December 14, 2005

Limerick Generating Station, Unit 1  
Facility Operating License No. NPF-39  
NRC Docket No. 50-352

**SUBJECT:** License Amendment Request  
Single Loop Operation Safety Limit Minimum Critical Power Ratio  
(SLO SLMCPR) Change

**Figure 1**  
**Reference Loading Pattern – Limerick 1 Cycle 11**

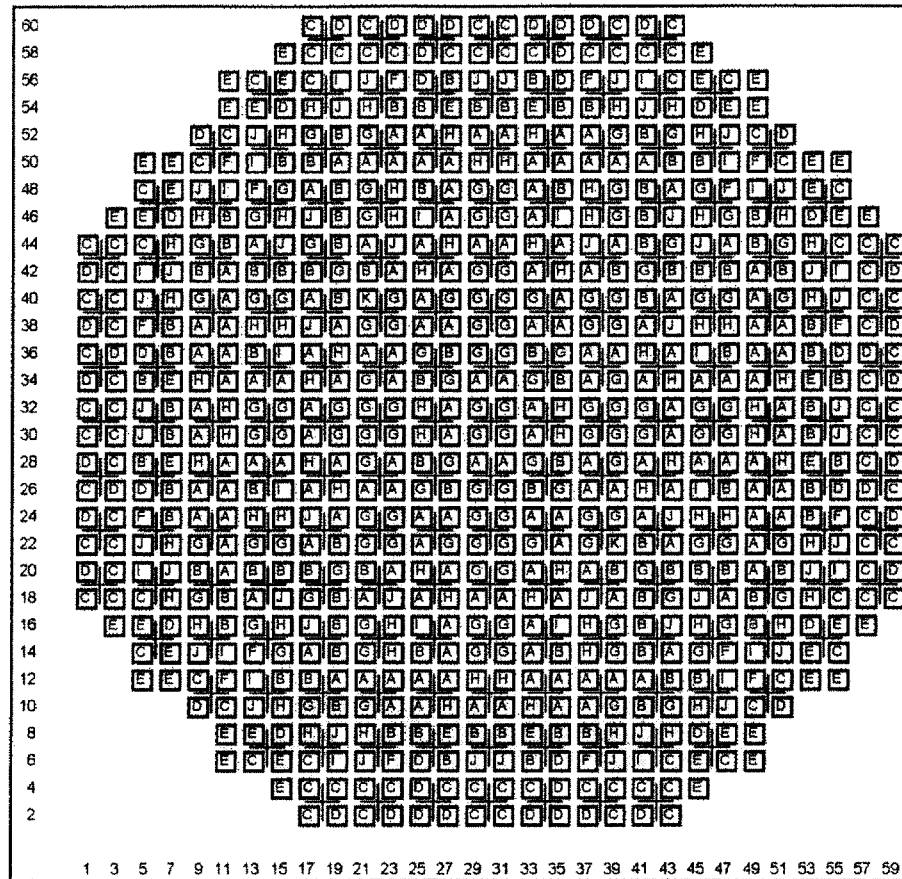
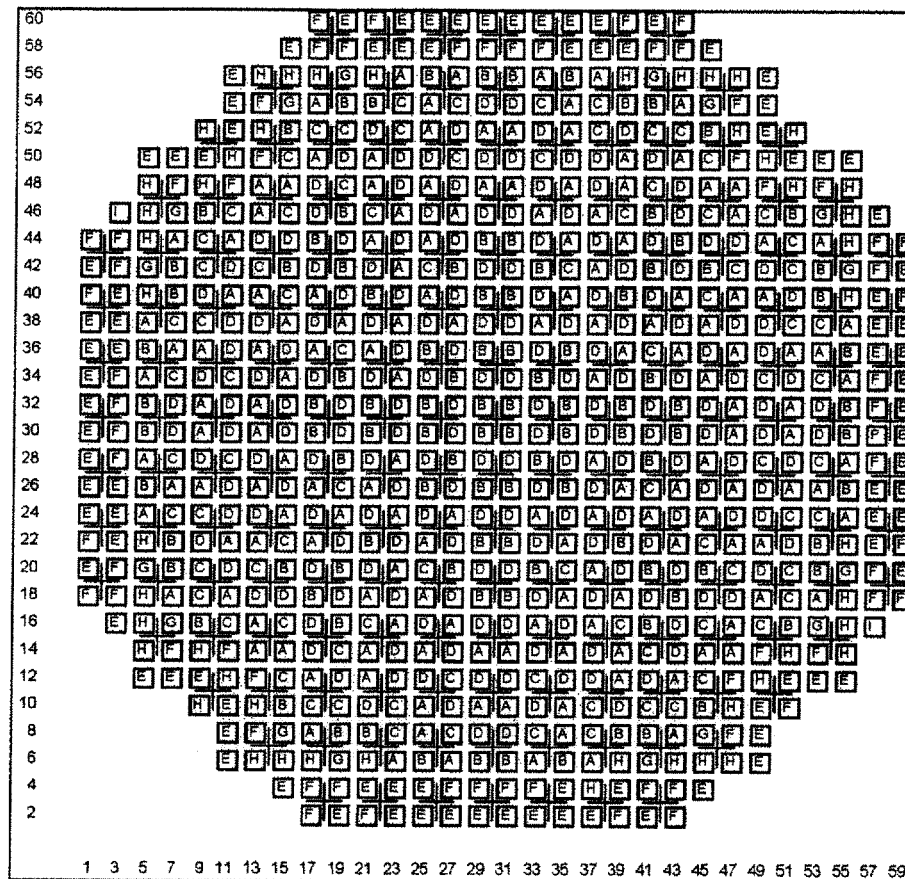
The core loading information for Limerick 1 Cycle 11 is provided in Figure 1. For comparison the core loading information for Limerick 1 Cycle 12 is provided in Figure 2. The impact of the fuel loading pattern differences on the calculated SLMCPR is correlated to the values of [[
